HILL VALLEY - PHASE 2B

CITY PROJECT NO. 15860
CONTRACT NO. 9680

REVISION 1 - 04/29/26

REVISION 2 - 05/28/26

15860
W-6

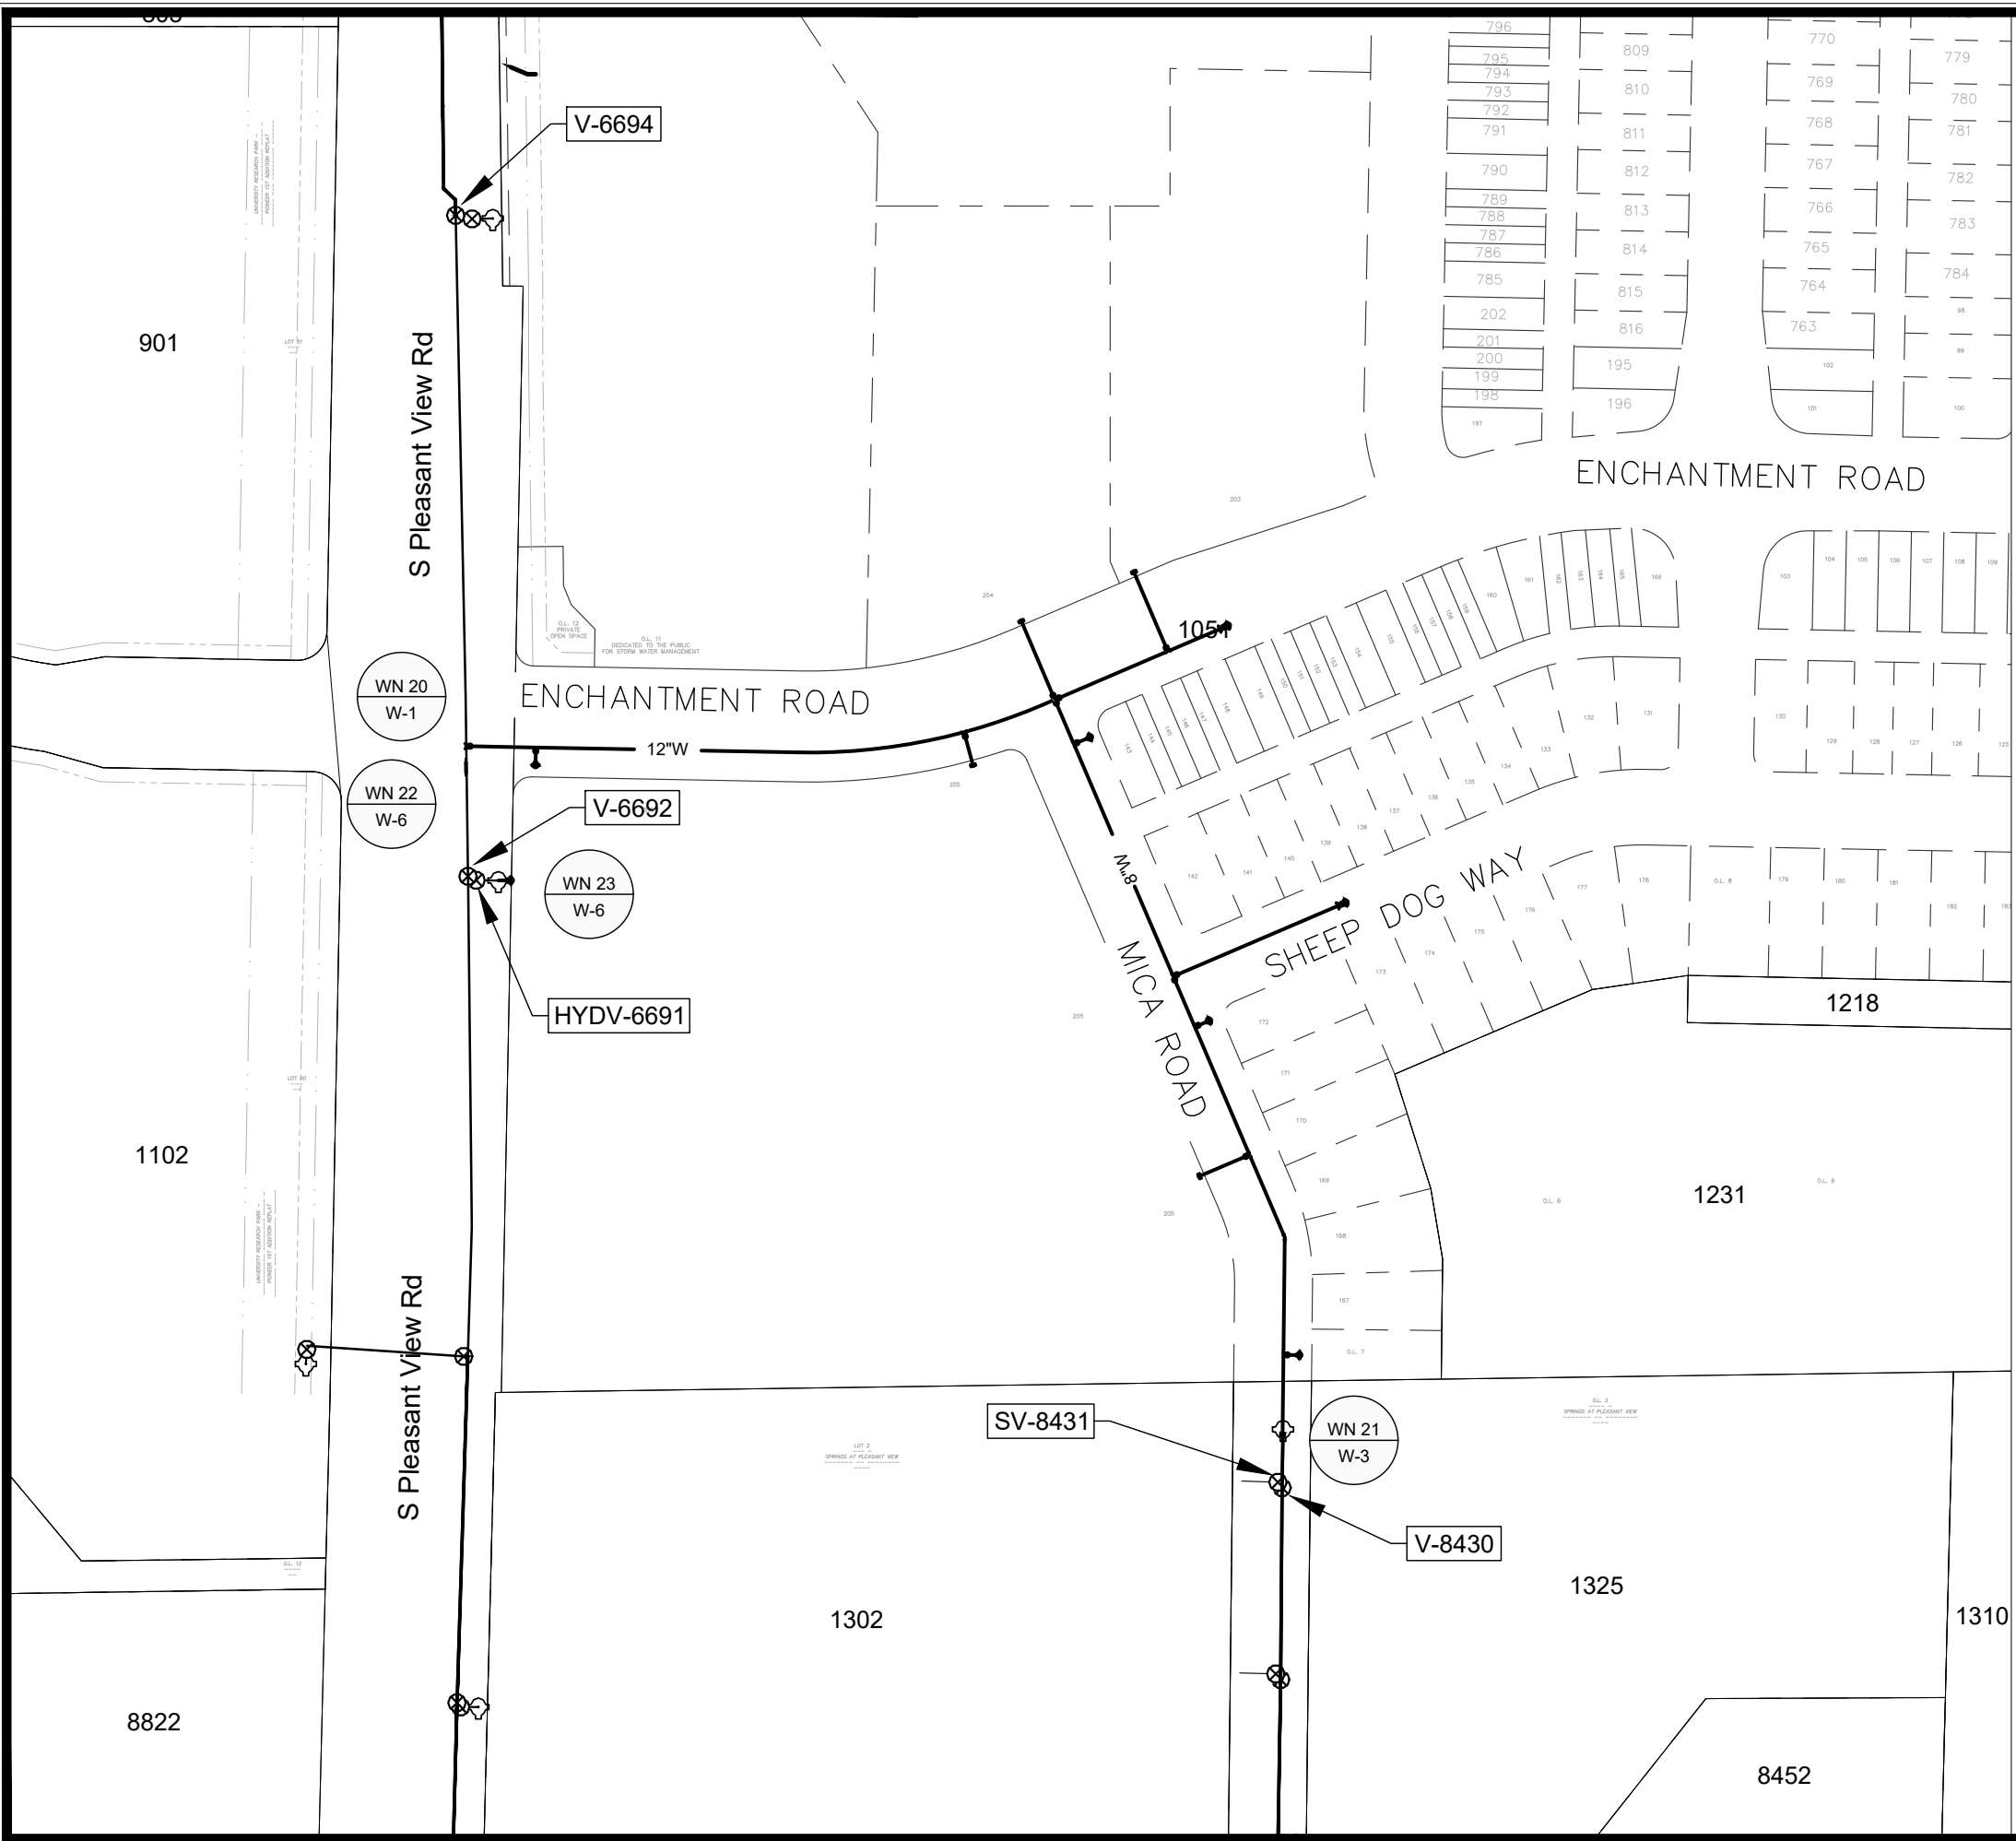
REVISION 2 5.28.26
REVISED STORM SEWER

15860
 L-1

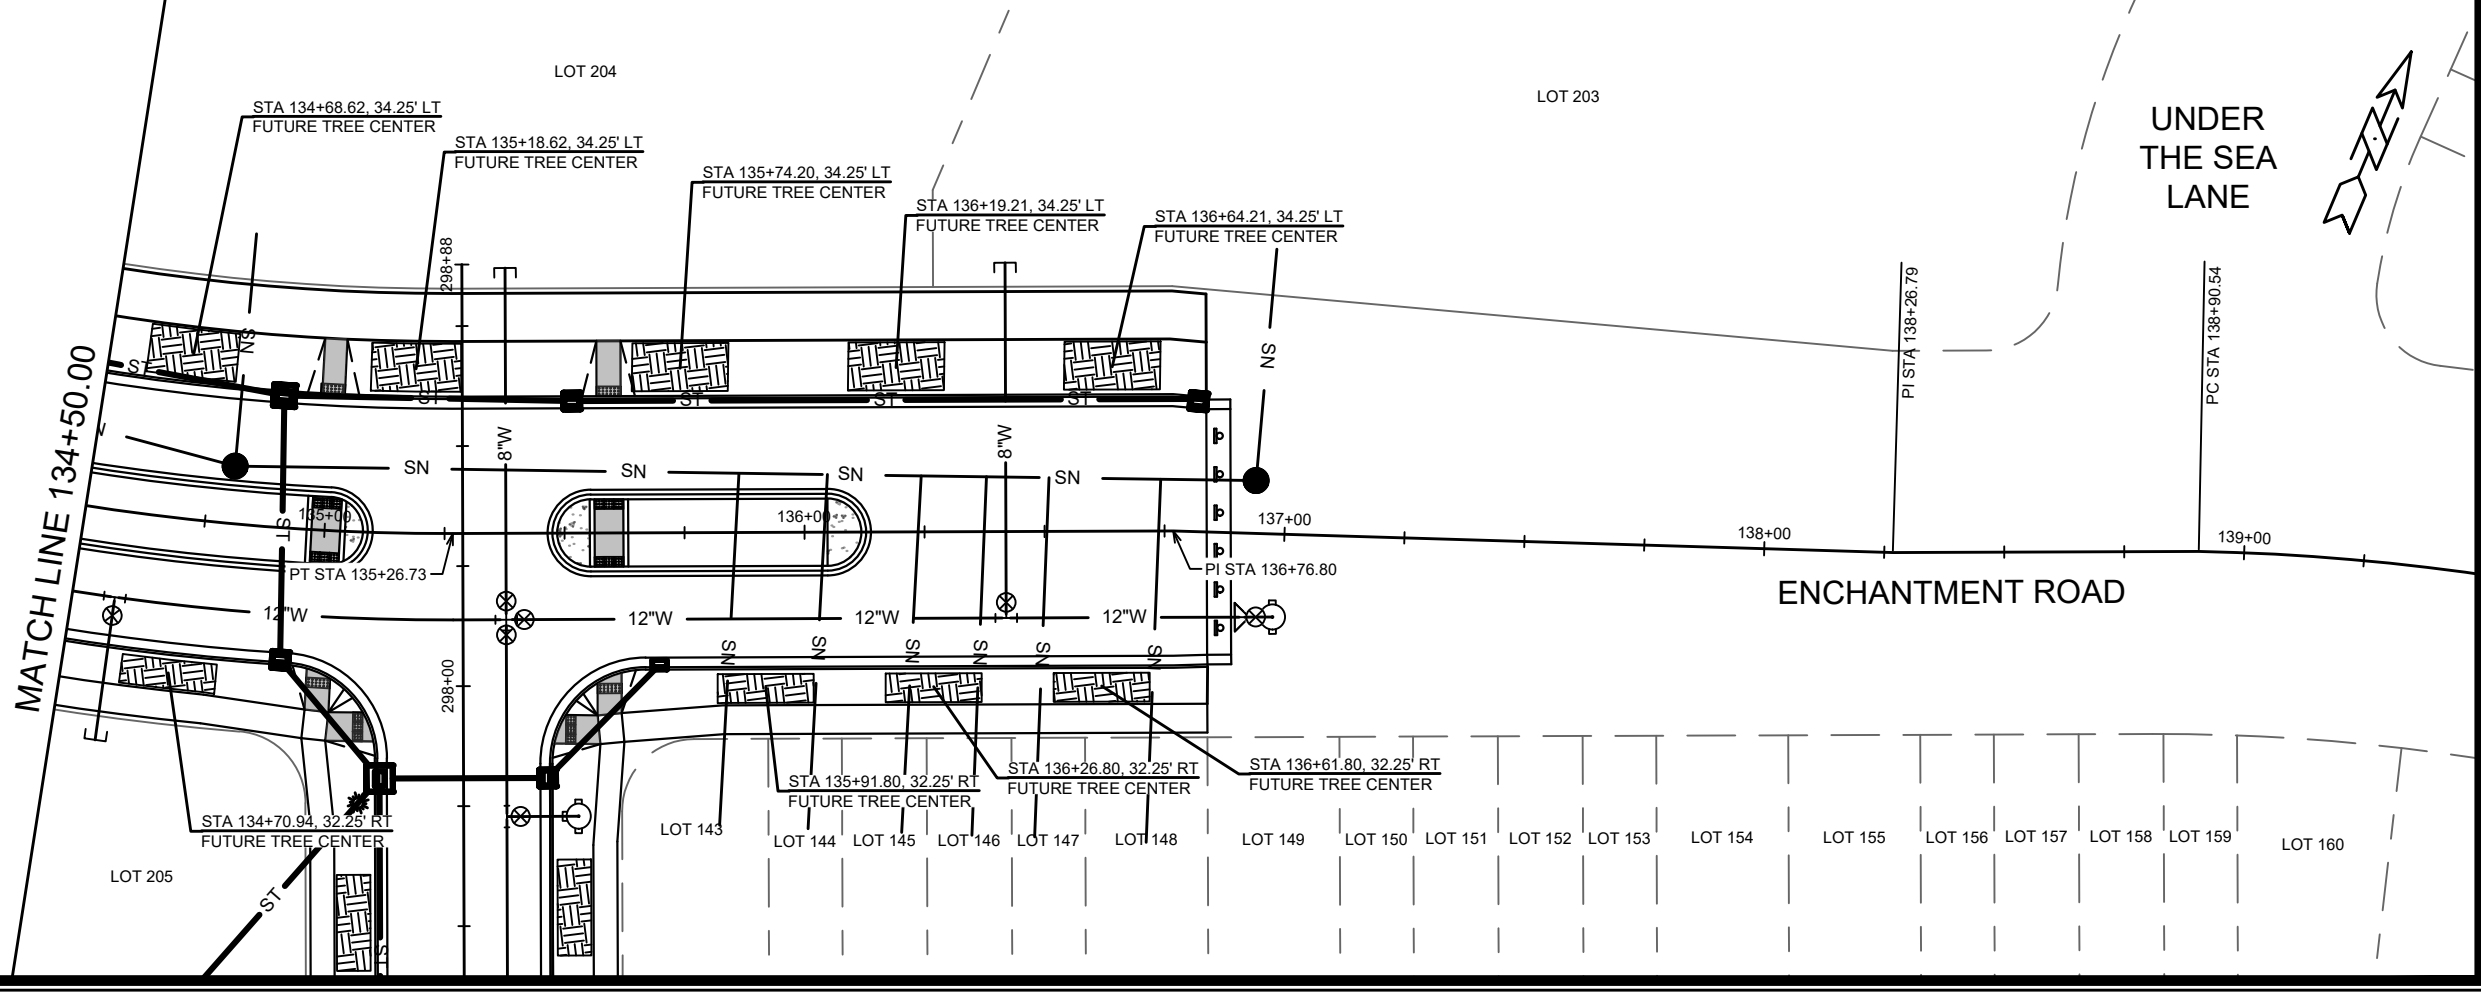
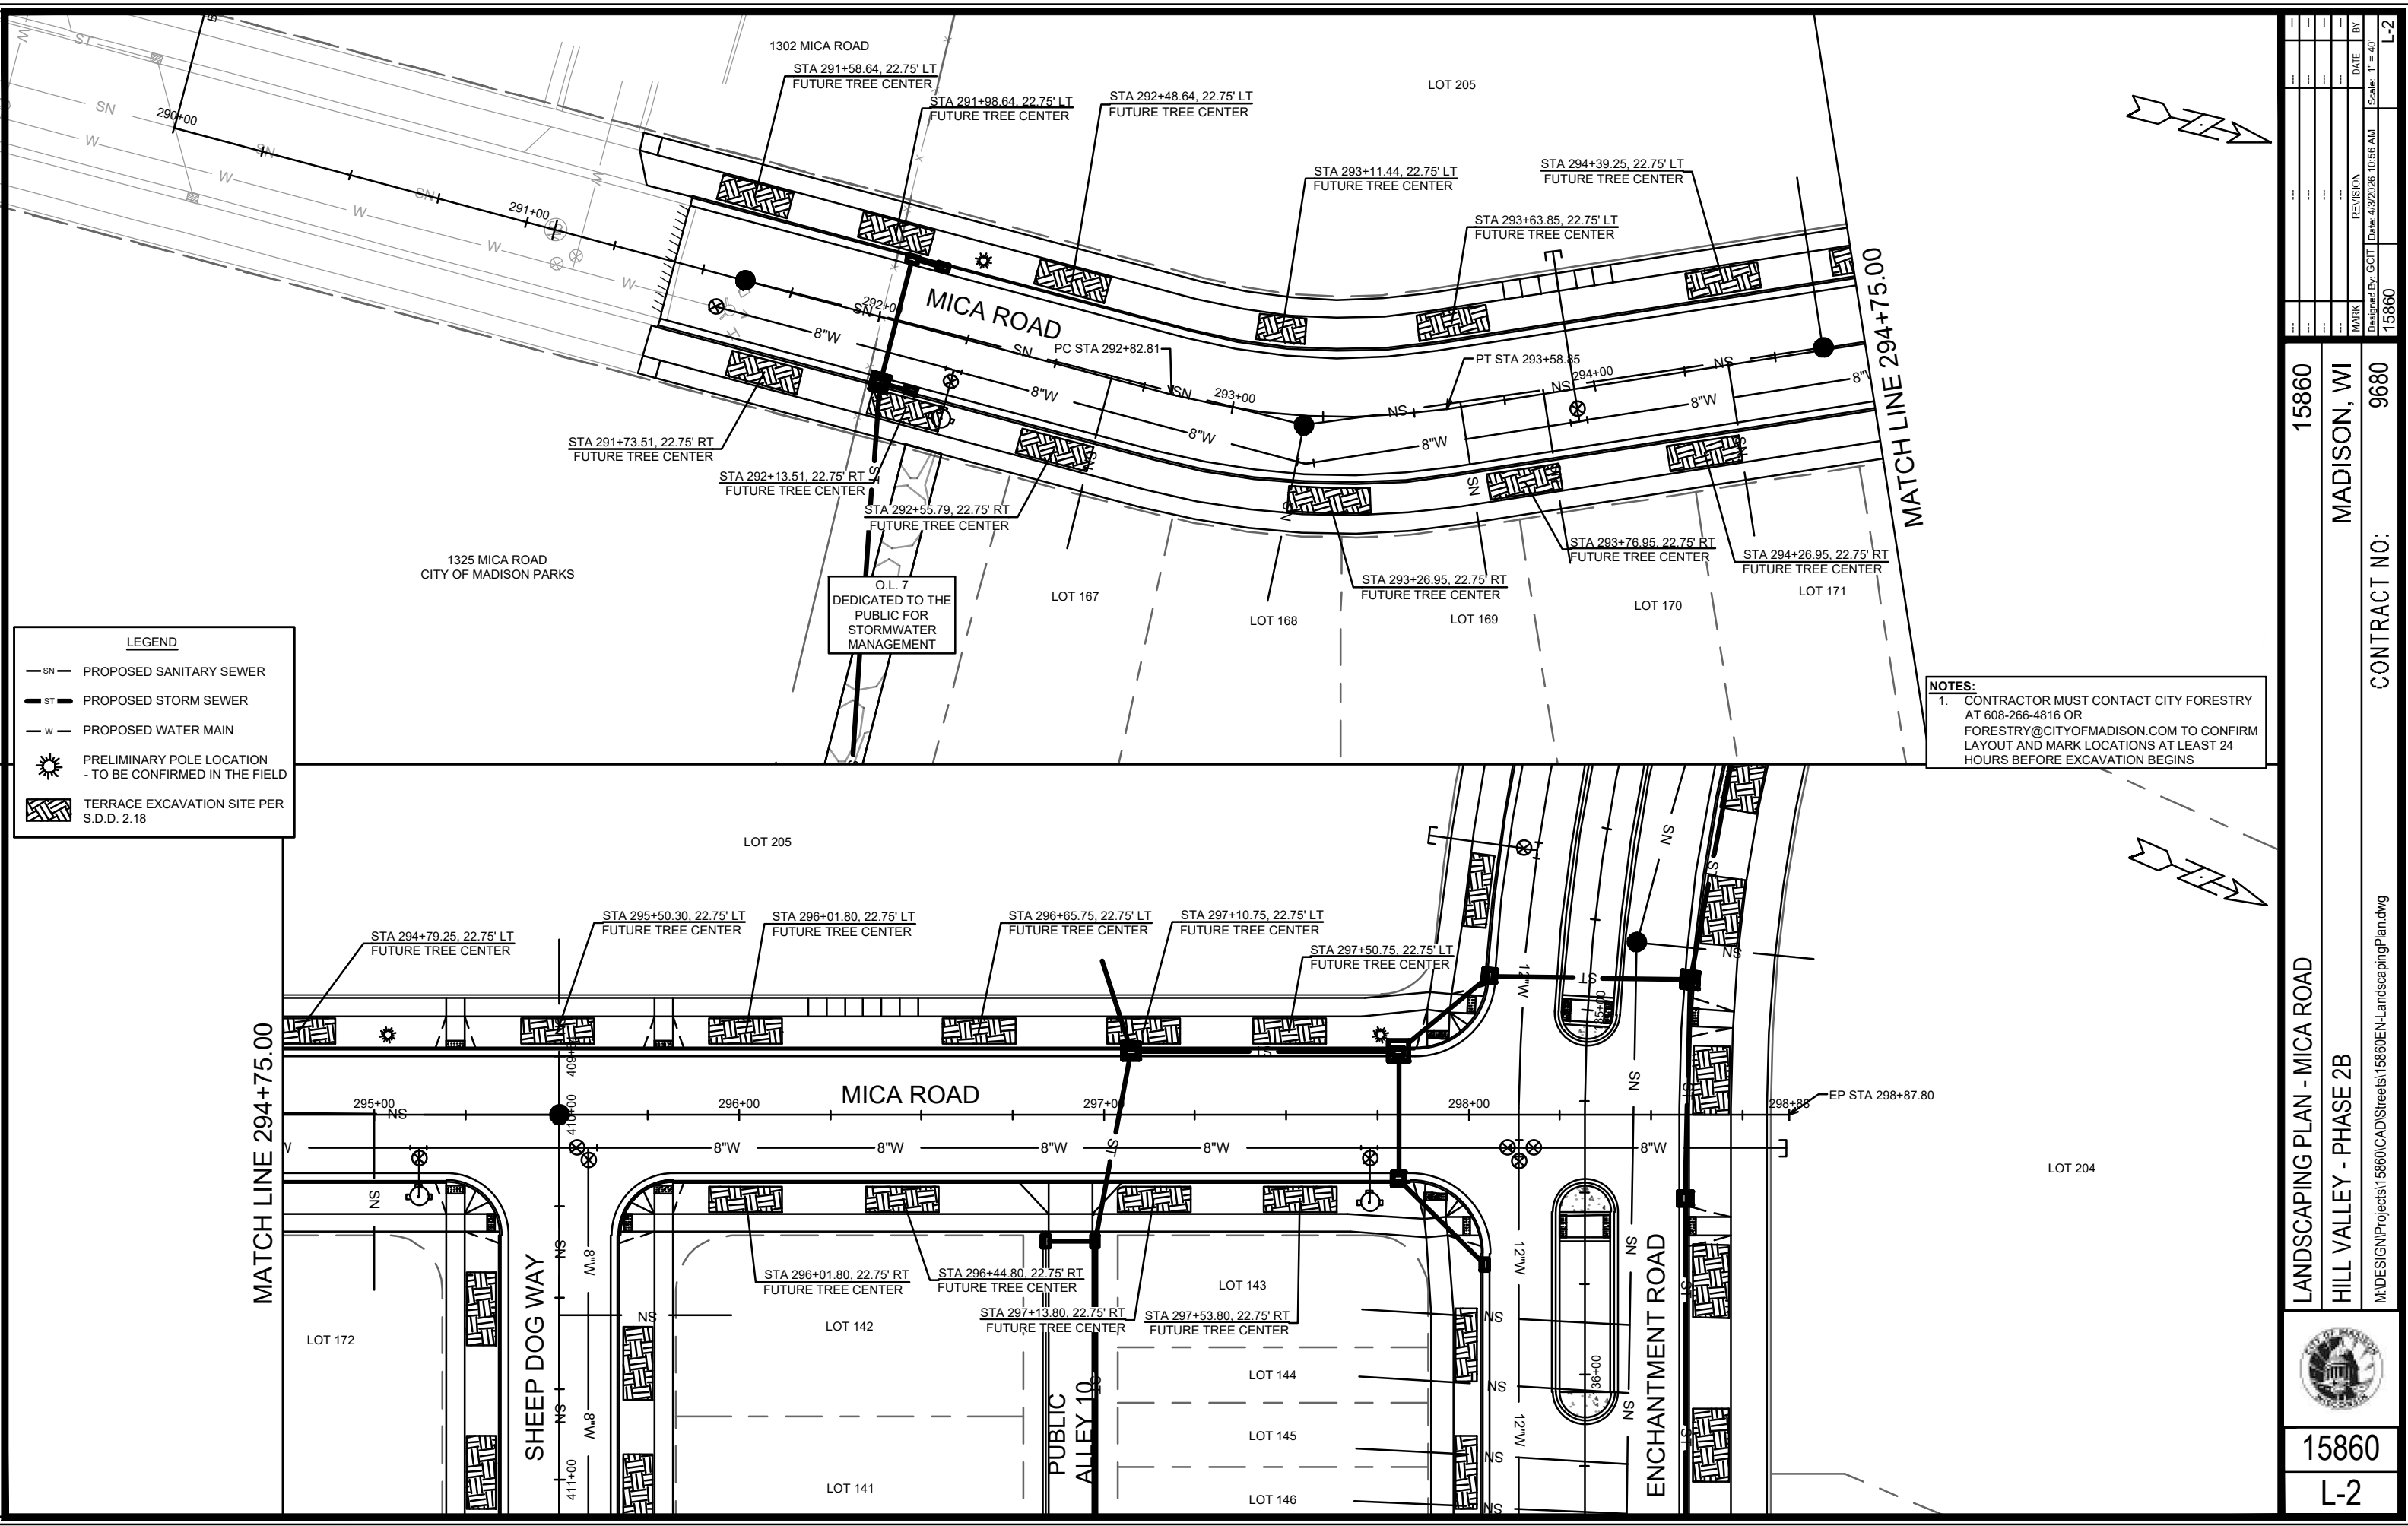
REVISION 2 - GCIT - 05/28/26
 - PLANTING SITE RELOCATION
 - UPDATED UTILITIES LAYOUT
